ADDENDUM #1

KITSAP COUNTY PUBLIC WORKS WASTEWATER DIVISION SILVERDALE PUMP STATIONS 19 & 31 UPGRADES

May 21, 2021

Drawing: **E19-4**

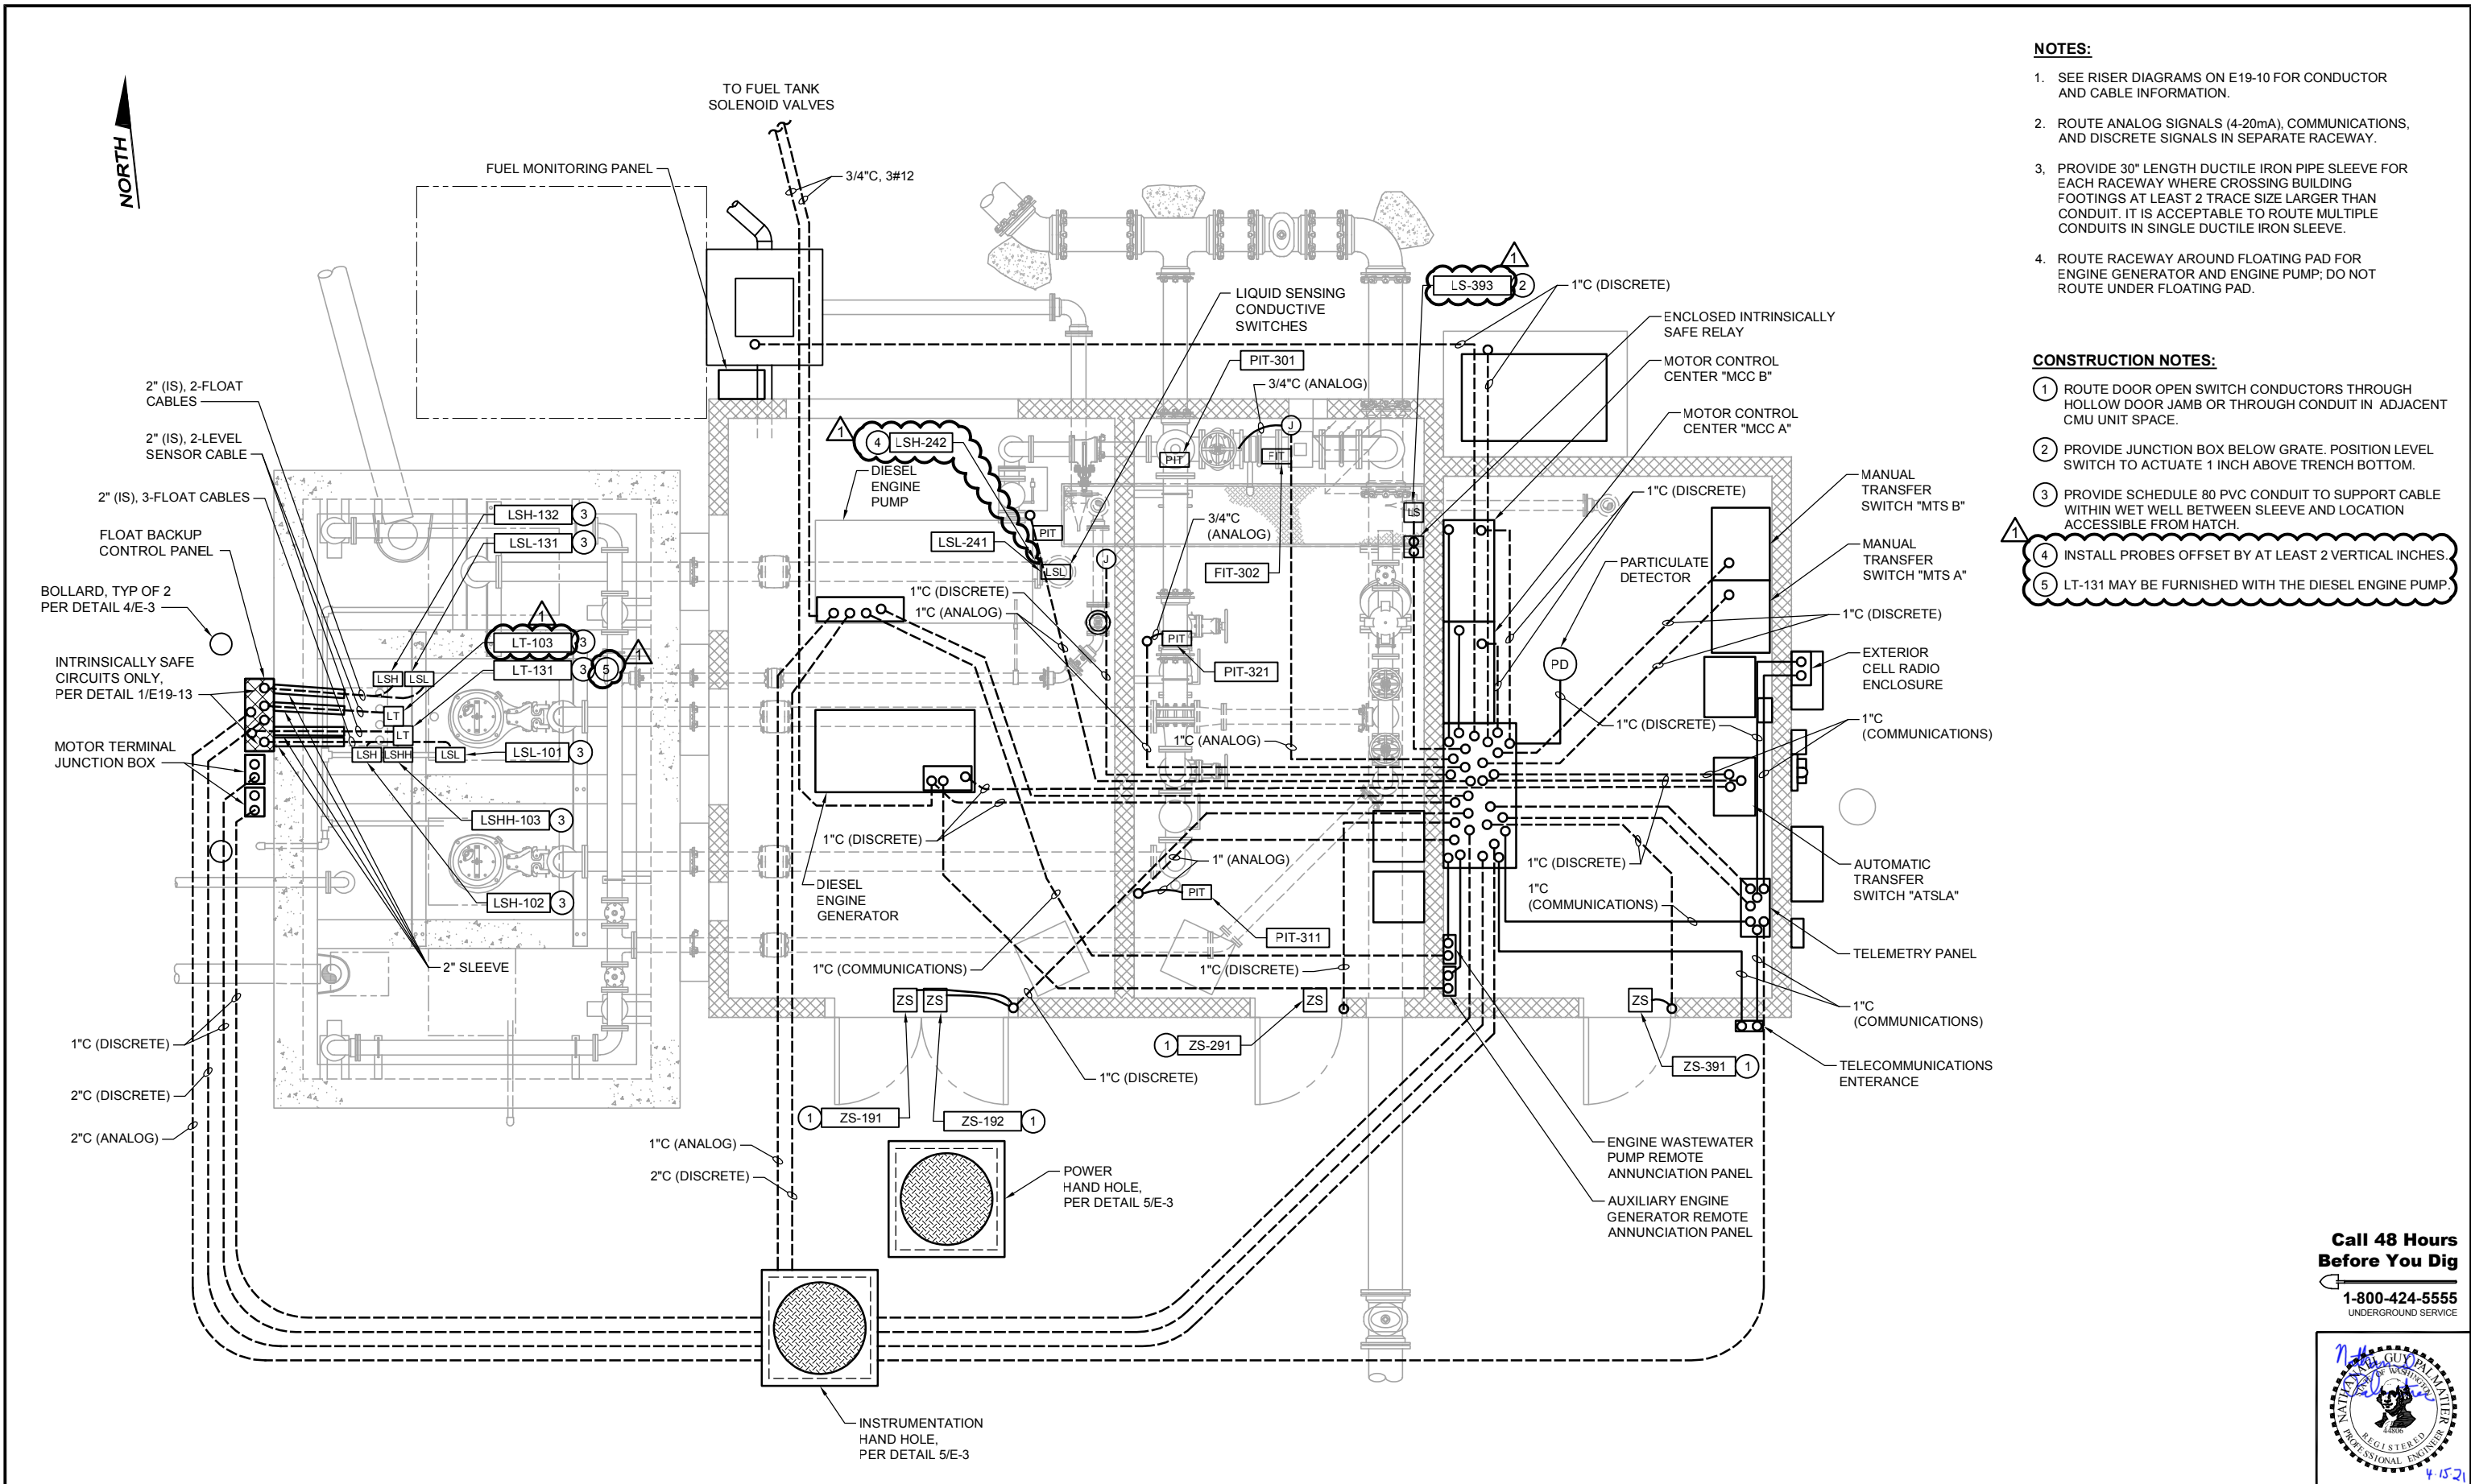
- Item 25. Drawing E19-4: REVISE the northern level transmitter to read “LT-103” in lieu of “LT-101” and “LSH-393” in lieu of “LS-292”.
- Item 26. Drawing E19-4: ADD instrumentation callout “LSH-242” with Construction Note 4 callout at the same locations as callout “LSL-241”. Construction Note 4 reads as follows:

- Install probes offset by at least 2 vertical inches.
- Item 27. Drawing E19-4: ADD Construction Note 5, which reads as follows:
- LT-131 may be furnished with the diesel pump engine.

- ROUTE DOOR OPEN SWITCH CONDUCTORS THROUGH HOLLOW DOOR JAMB OR THROUGH CONDUIT IN ADJACENT CMU UNIT SPACE.
- PROVIDE JUNCTION BOX BELOW GRATE. POSITION LEVEL SWITCH TO ACTUATE 1 INCH ABOVE TRENCH BOTTOM.
- PROVIDE SCHEDULE 80 PVC CONDUIT TO SUPPORT CABLE WITHIN WET WELL BETWEEN SLEEVE AND LOCATION ACCESSIBLE FROM HATCH.
- INSTALL PROBES OFFSET BY AT LEAST 2 VERTICAL INCHES.
- LT-131 MAY BE FURNISHED WITH THE DIESEL ENGINE PUMP.

Drawing: **C31-3**

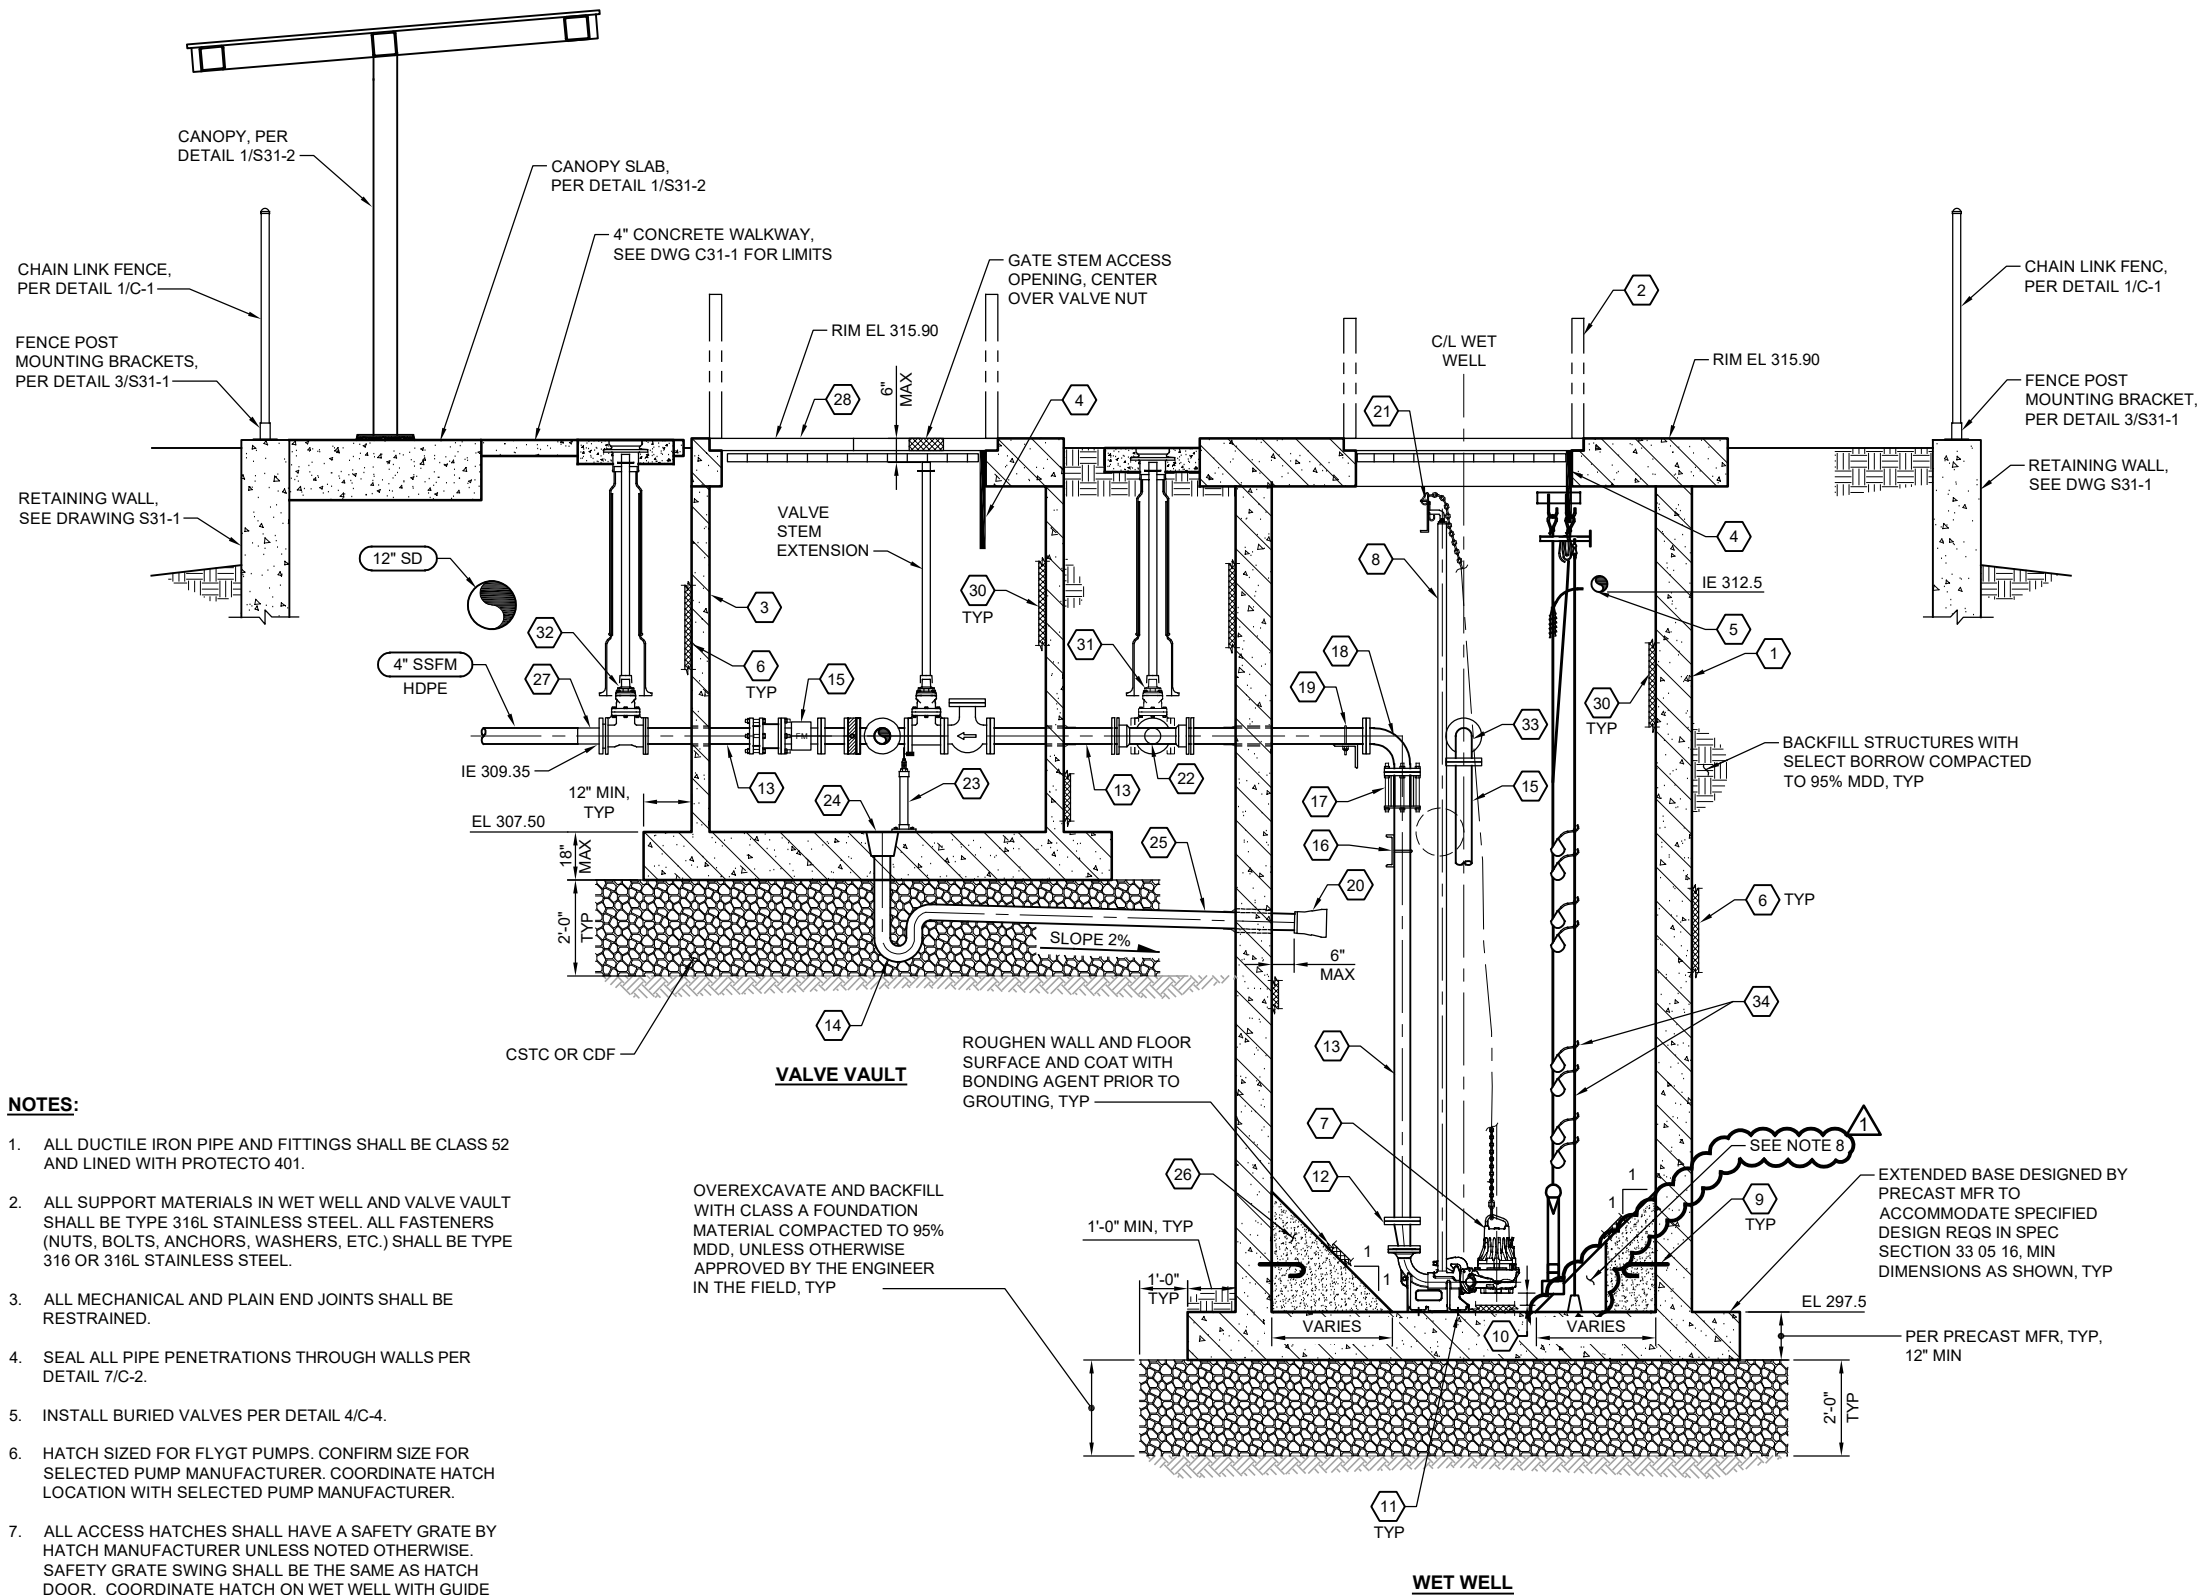
- Item 29. Drawing C31-3: REVISE grout fillet to provide a blocked out, flat-bottomed area for the pressure transducer and added Note 8 which read as follows:

8. Adjust dimensions of flat area around pumps, discharge elbow, pressure sensing level probe, and level floats to provide 6” clearance. Hold back grout as required to provide 6” clearance for discharge elbow, pressure sensing level probe, and level floats.

- Item 30. Drawing C31-3: CLARIFICATION: A monolithic poured wet well base with sloped walls is an acceptable substituted to the grouted slope walls called out by Pump Station Component #26, provided the prescribed slopes are maintained and a flat-bottomed notch is provided for the Pressure Transducer per Construction Note 8.

- Item 31. Drawing C31-2 and C31-3: CLARIFICATION: The precast vault dimensions identified for the valve vault are considered the minimum required dimensions. Large dimensions may be considered to be equal provided the larger dimensions do not adversely impact other items associated with the upgrades.

8. ADJUST DIMENSIONS OF FLAT AREA AROUND PUMPS, DISCHARGE ELBOW, PRESSURE SENSING LEVEL PROBE AND LEVEL FLOATS TO PROVIDE 6\"/>

Drawing: **E31-2**

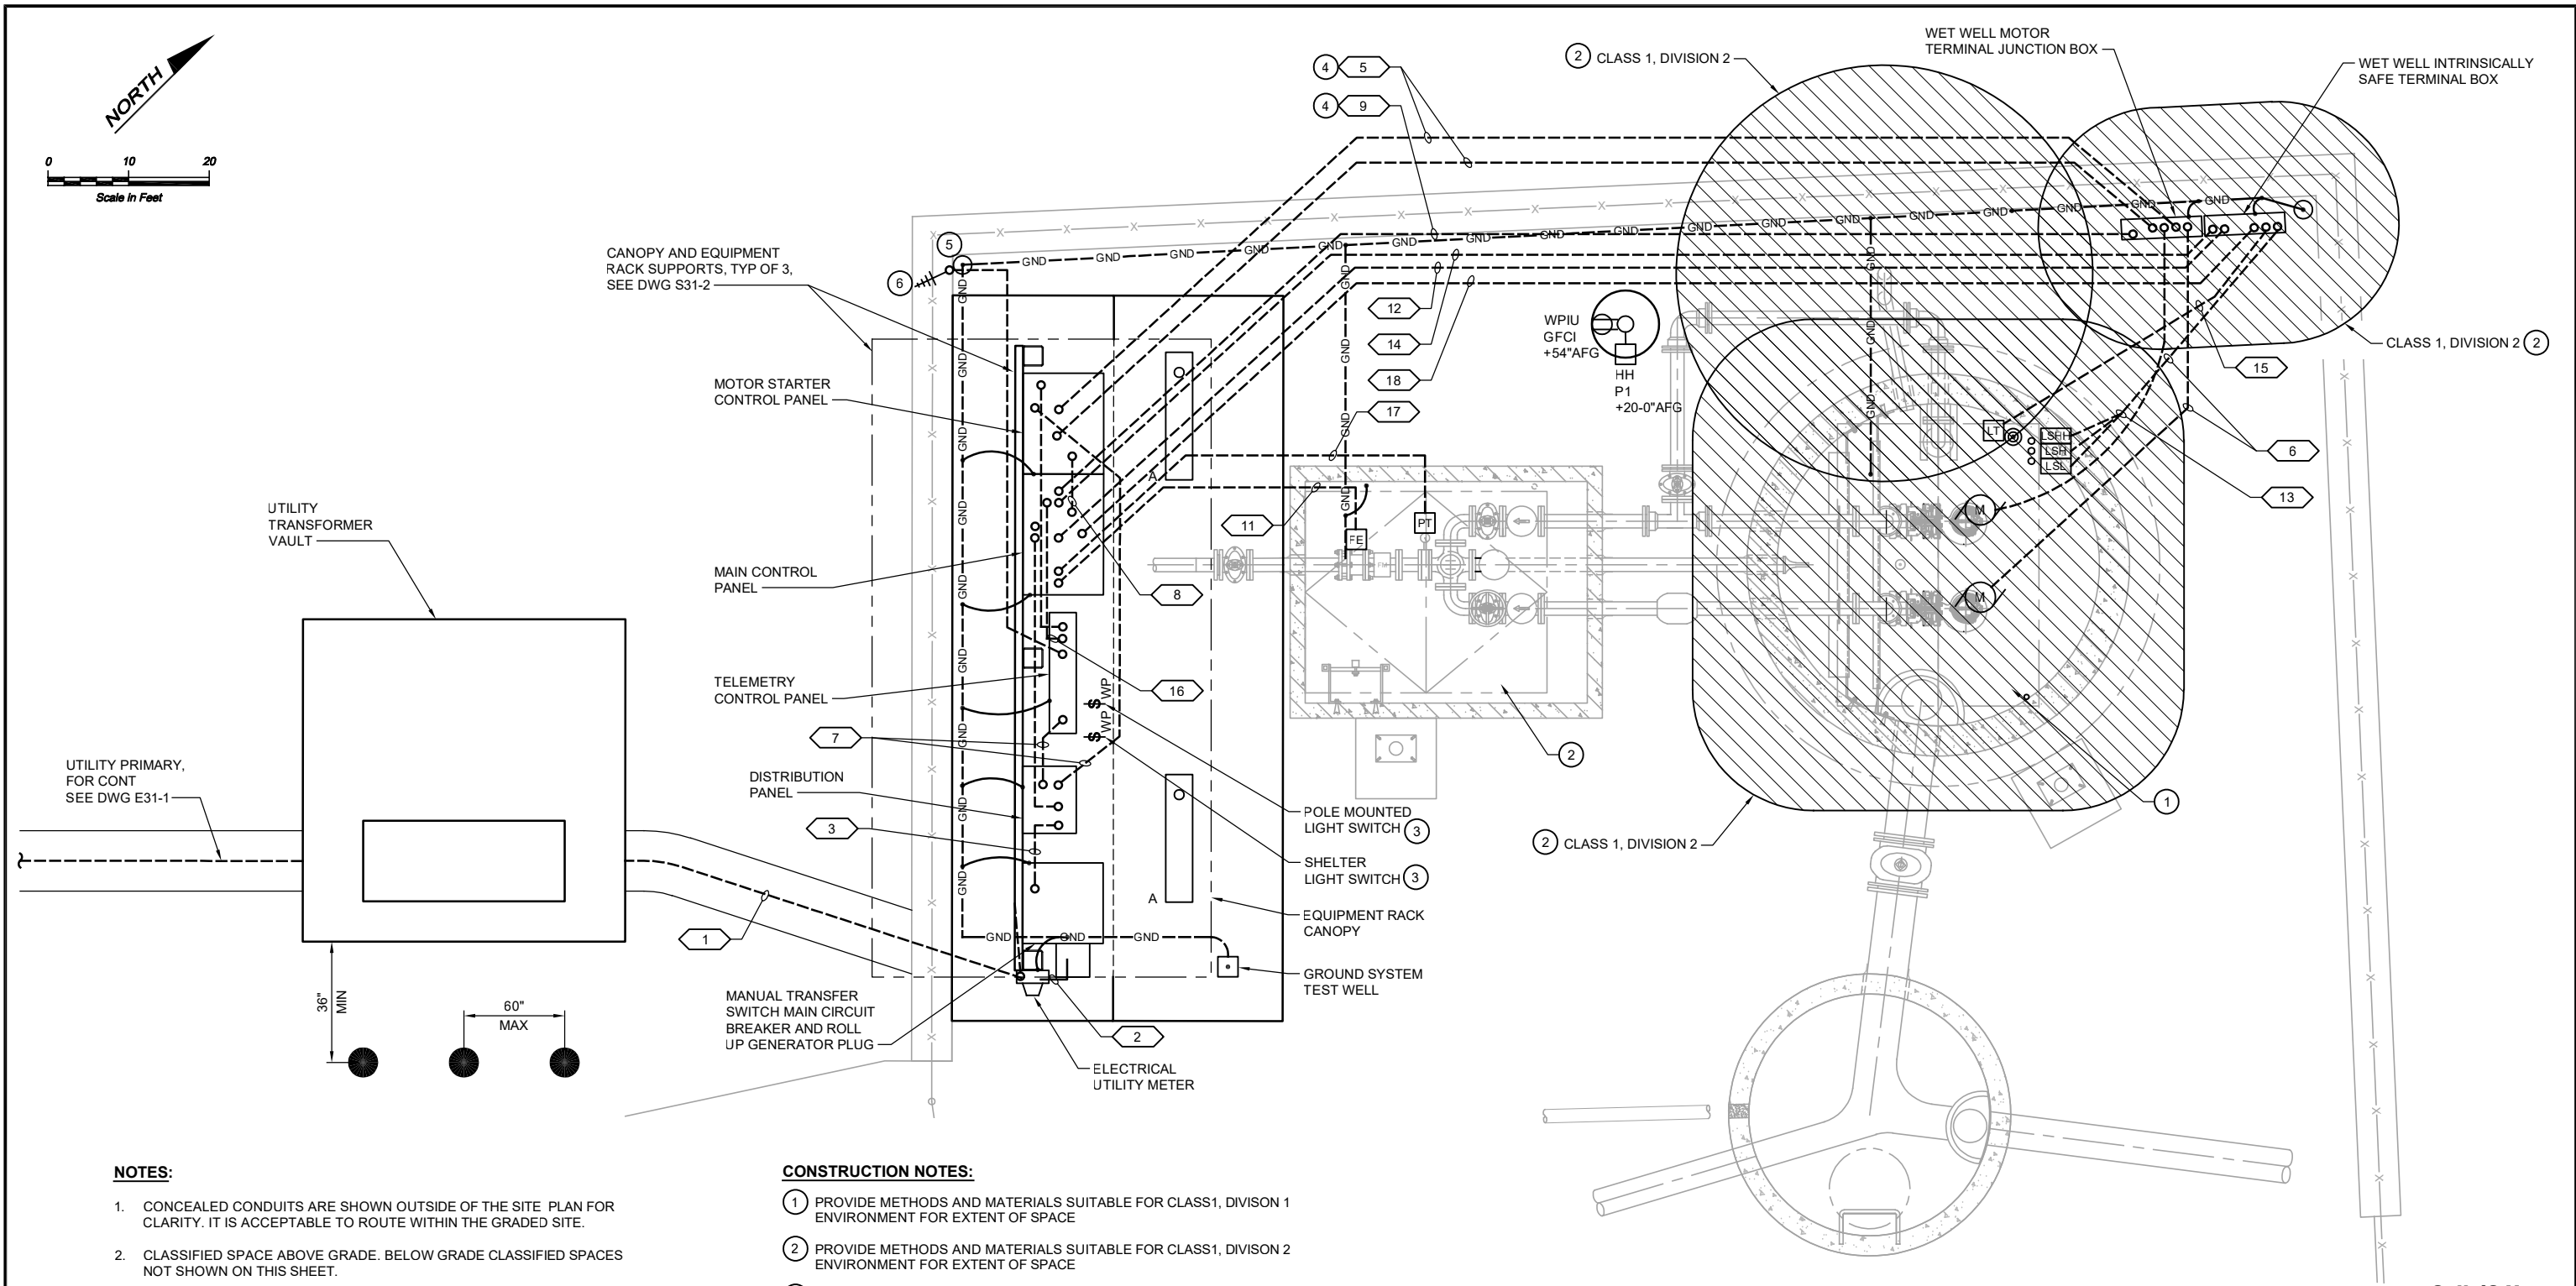
Item 21. CLARIFICATION: Drawings C19-2, C19-5, and C31-2 reference Detail 3/C-4, which indicates pressure transmitters are required at force main locations. The pressure gauges are identified on E19-4 and E31-2 as follows:

PIT-301 Force Main at PS 19
PIT-311 Submersible Pump 1 at PS 19
PIT-321 Submersible Pump 2 at PS 19
PIT Diesel Pump at PS 19
PT Force Main at PS 31
